Technical Service Bulletin: tsb100153

Released Date: 12-Mar-2002

Articulated Piston Power Cylinder Update

Fig. 1, Cylinder Liner Part Number Location

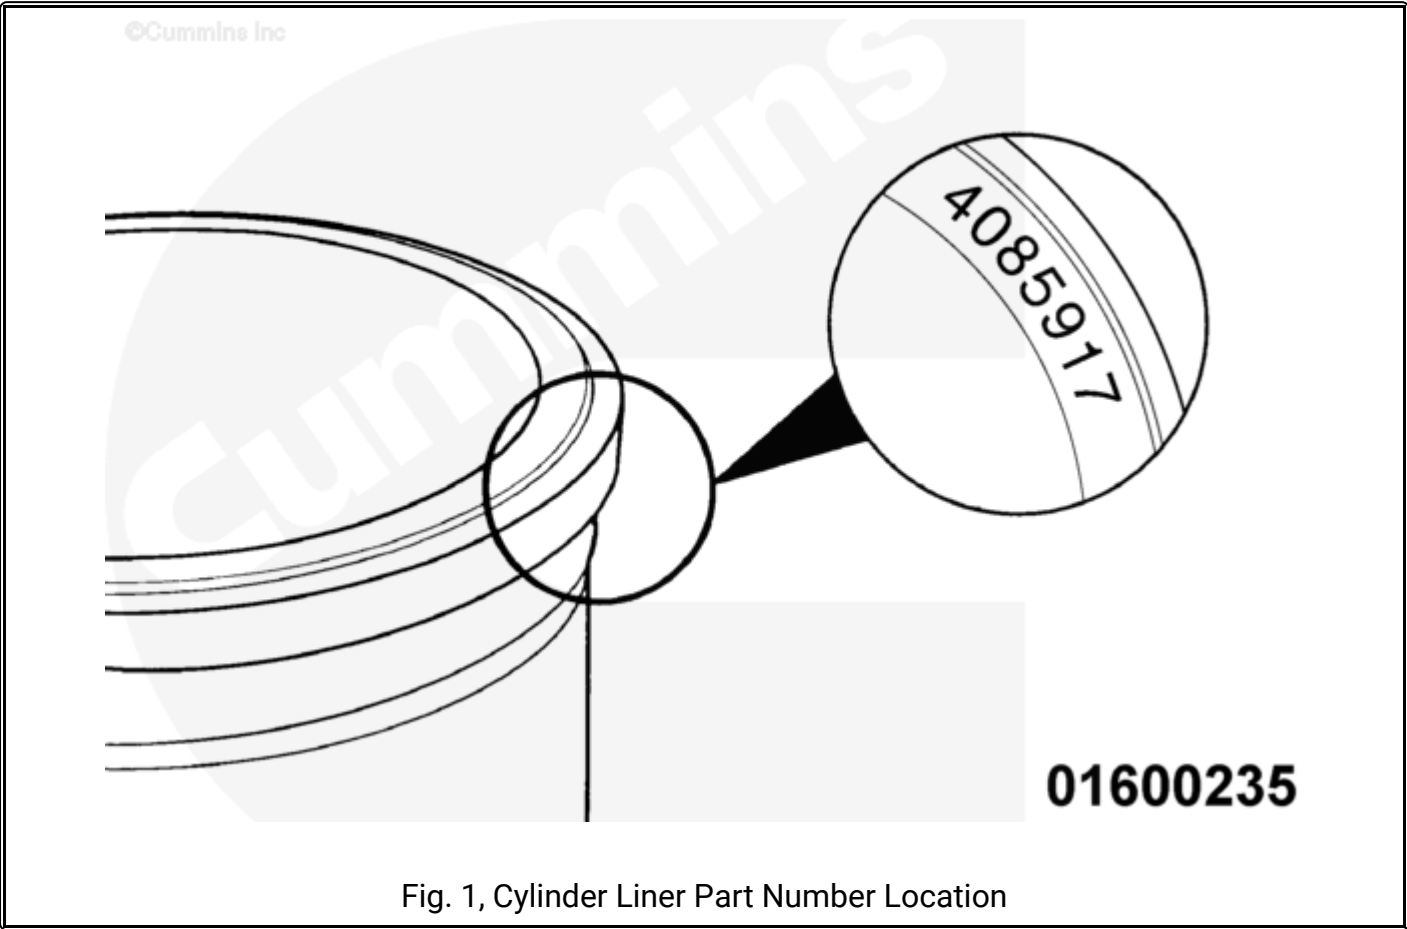
The new cylinder liner, Part Number 4085917, has been nitride hardened for improved robustness and supersedes the old cylinder liner, Part Number 3410342. The new cylinder liner is dimensionally the same as its predecessor. Use Table 1 for component part numbers and Table 2 for Service Kit part numbers.

When the new-hardened cylinder liner is unused it is duller in appearance when compared to the old cylinder liner because of the nitride hardening. However, the only certain method to tell the difference between the cylinder liners is by the part number identification, stamped into the cylinder liner. See Fig. 1. Visual inspection of the top piston ring part number is also required to determine correct part number piston ring. Use Fig. 2.

Fig. 2, Piston Ring Part Number Location

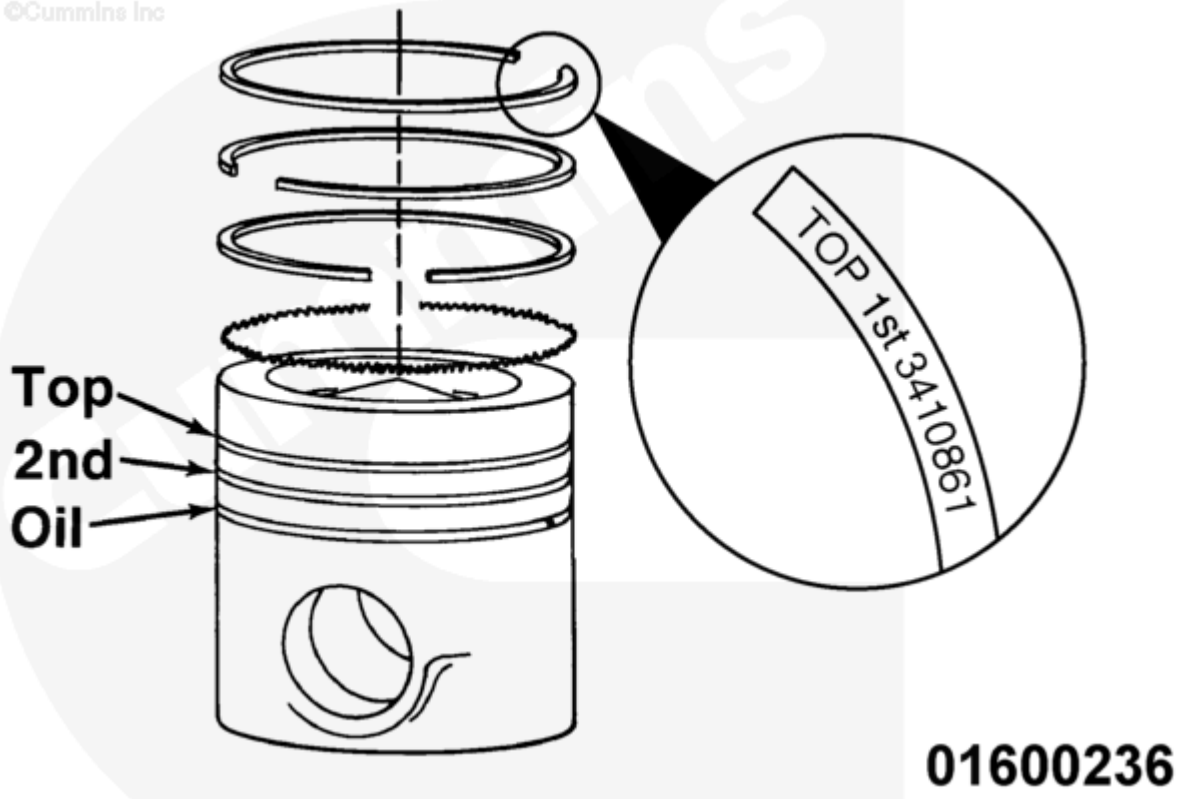
The new top piston ring, Part Number 3410861, is a cast iron ring with a wrap around hard particle chrome. The old top piston ring, Part Number 3070589, is **not** to be used with the new hardened cylinder liner. The old piston ring is **not** obsolete because it is used on some K38, K50 and QSK19 engines. The middle and bottom piston rings remain the same and are not affected by this product improvement. Use Table 1 for component part numbers and Table 2 for Service Kit part numbers.
